**DAM SAFETY SECTION
CRITICAL INFRASTRUCTURE DIVISION**

Downstream Hazard Assessment

DAM: Lake Deerwood Dam

INSPECTION DATE: May 22, 2012

Figure 2: Sketch of Dam with Photo Locations

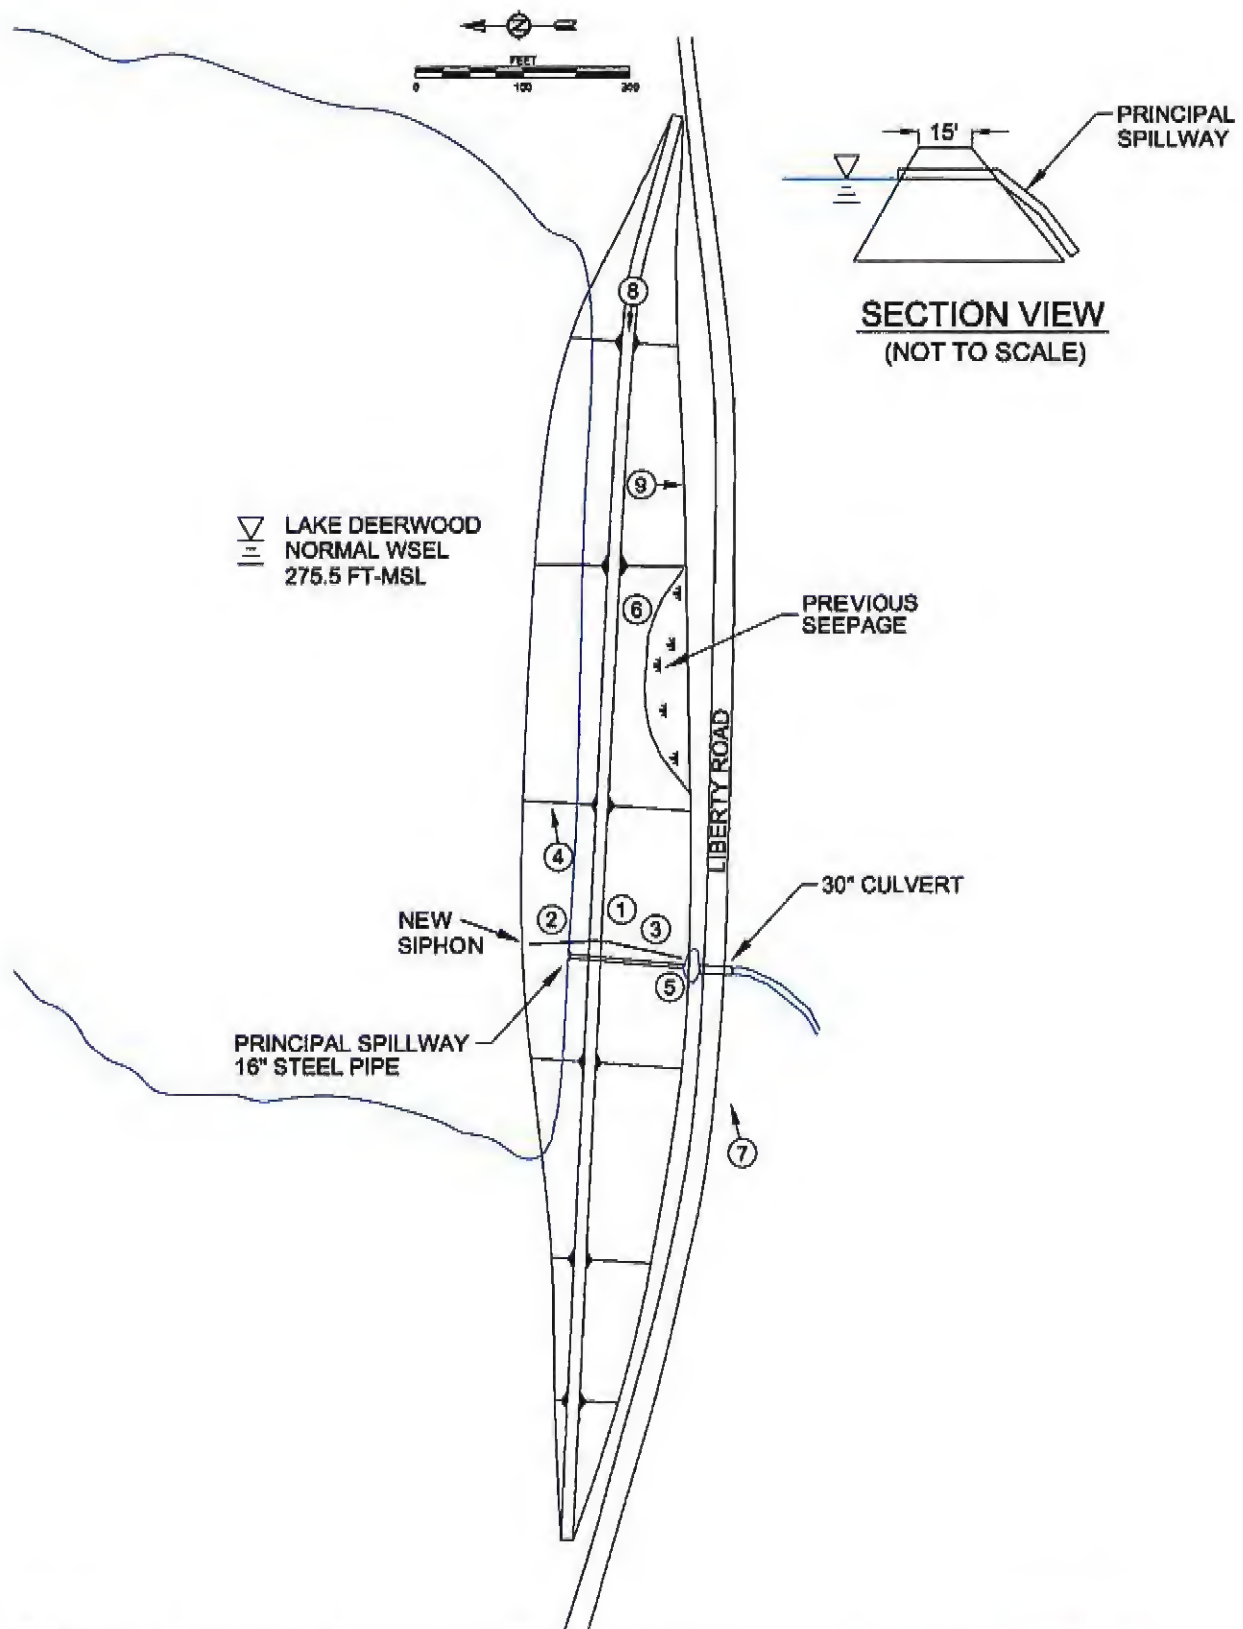
- An 8-inch PVC siphon was installed over the embankment to maintain the water level below the level of the damaged principal spillway inlet [Photos 1-3],

- The water level was measured with a hand level to be 3.6 feet below the crest of the principal spillway and 8.7 feet below the top of dam [Photo 4],
- Standing seepage was observed on the toe of the dam near the principal spillway [Photo 5],

- The high phreatic surface on the downstream slope that was observed in the March 2010 inspection (when the principal spillway was engaged) was not observed during the current inspection [Photo 6],

- Small trees were growing back from cut stumps [Photos 7-8], and
- Cut trees that were on the embankment in the March 2010 inspection had been removed.

1. 
2. Per 30 Texas Administrative Code (TAC) Chapter 299, §299.43(a), a written O&M plan is required to be developed.
3. The hydrologic/hydraulic analysis submitted to TCEQ on February 3, 2012 should be revised and completed to demonstrate safe passage of the 75% PMF. Please refer to the March 15, 2012 comment letter from TCEQ to JPI.
4. The construction plans submitted to TCEQ on February 3, 2012 should be revised and completed. Please refer to the March 15, 2012 comment letter from TCEQ to JPI. Please note that construction plans must be approved by TCEQ before construction may commence.
5. Given the poor condition of the dam, the lake level should be maintained at a level well below the invert of the rusted out principal spillway pipe until permanent repairs can be completed.
